RISOGRAPH

TECHNICAL INFORMATION

SUBJECT: Modification Disposal Unit 1 + 2 — Issue T - 5

MODEL: 2700 — **Revised M - 002**

MOD # 1

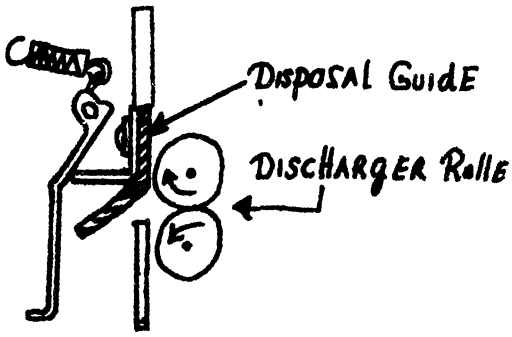
RISO, Inc. Technical Department has received field reports of Disposal Belt Stretching of Breaking. Two modifications have been added to the machines to correct this problem.

MODIFICATION 1. Disposal Guide Plate Part # 007-14120-000 Qty 1

All machines up to Serial Number 90410092 need to be modified to include Disposal Guide. (See figure on next page for mounting instructions.)

MOD # 2

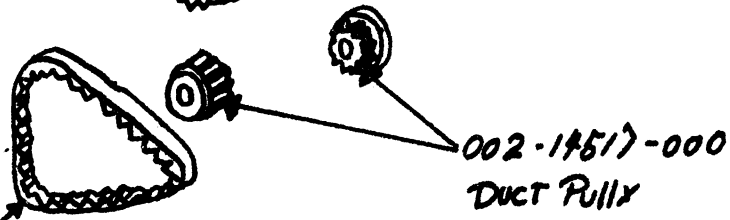
MODIFICATION 2.

Duct Pully	Part # 002-14517-000	Qty 2
Pully Gear 3M; M = RMV	Part # 007-14121-006	Qty 1
264-3M-6 Keblar Cord	Part # 620-03066-015	Qty 1

All machines up to serial number 90410445 need to be modified to include the new pully system. (See figure on next page for instructions.)

620-03066-105
264-3M-6 KeBlar Cord
